DATE OF BULLETIN:

10-17-2017

MODELS AFFECTED:

PRO GTX XR

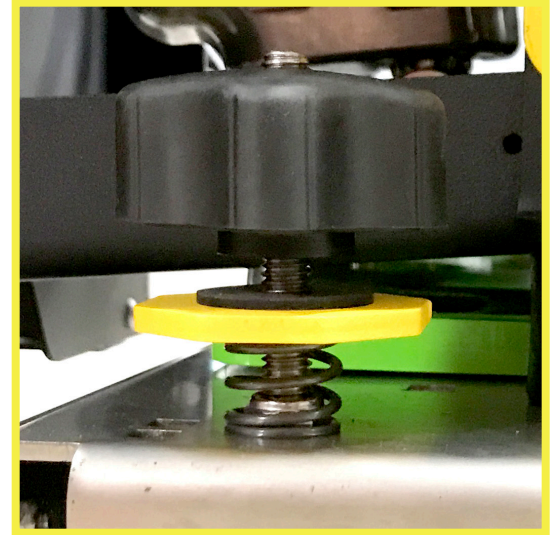
Shroud Wipers moving out of adjustment over time

Spring underneath Shroud Adjustment Knob

Rubber Washer on top of Shroud Adjustment Knob

All Disk and EDGE Rider Scrubbers include new Rubber Washer (Part #: H-4440040) and Support Spring (Part #: 4-386) surrounding the Shroud Adjustment Knob. The Spring that is supported by the Deck, ensures that the Adjustment Knob will not self adjust down over time from machine usage. The Rubber Washer that now sits on top of the Adjustment Knob is to reduce rattle with the machine in operation.
